2021 Annual Inspection Report Wood Dump and Former Army Landfill

Environmental Long-Term Monitoring and Inspection Former U.S. Disciplinary Barracks (USDB) Lompoc, California

Review Comments									
Project	Environmental Long-Term Monitoring, Former U.S. Disciplinary Barracks (USDB)	Contract No.	W912PL-18-D044						
Document	Draft Final 2021 Annual Inspection Report, Wood Dump and Former Army Landfill	Date	June 2022

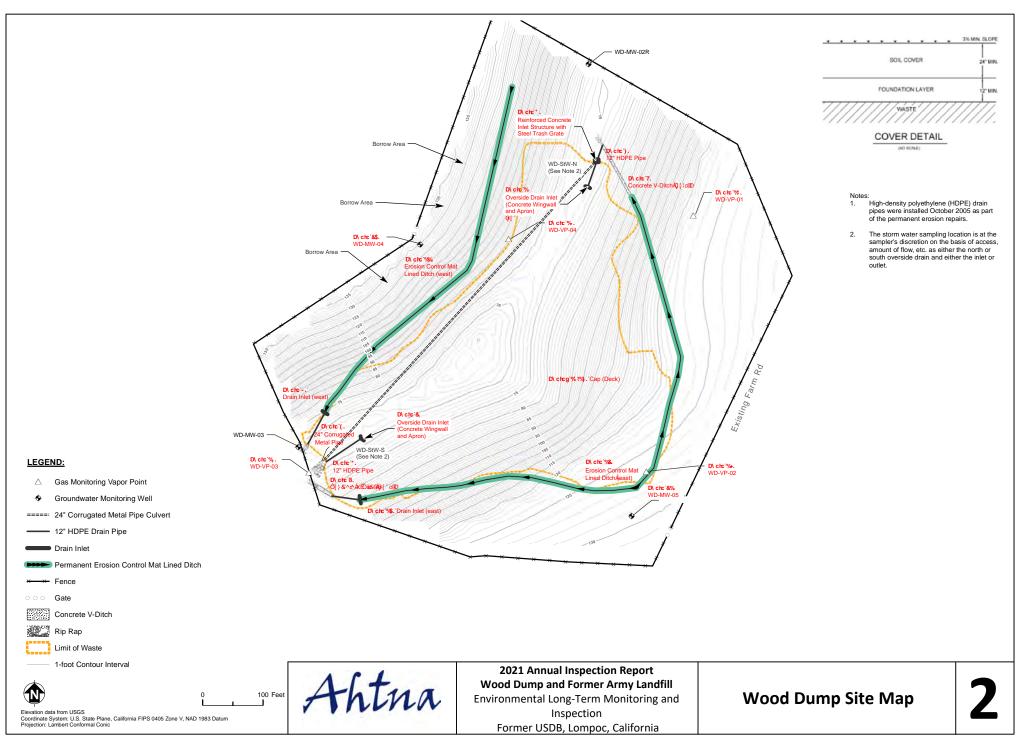
5	BL	PDF Pg 28	Inspection Checklist	N/A	In future inspections, please verify and document that the groundwater monitoring wells are also secure and locked.	Agreed. Future inspection checklists will include security verification of groundwater monitoring wells.
6	BL	PDF Pg 31	Appendix D	N/A	Figure 2 says photo 7 is v-ditch south.	Agreed. Figure 2 updated accordingly.
7	BL	PDF Pg 31	Appendix D	N/A	Figure 2 says photo 8 is v-ditch north	Agreed. Figure 2 updated accordingly.
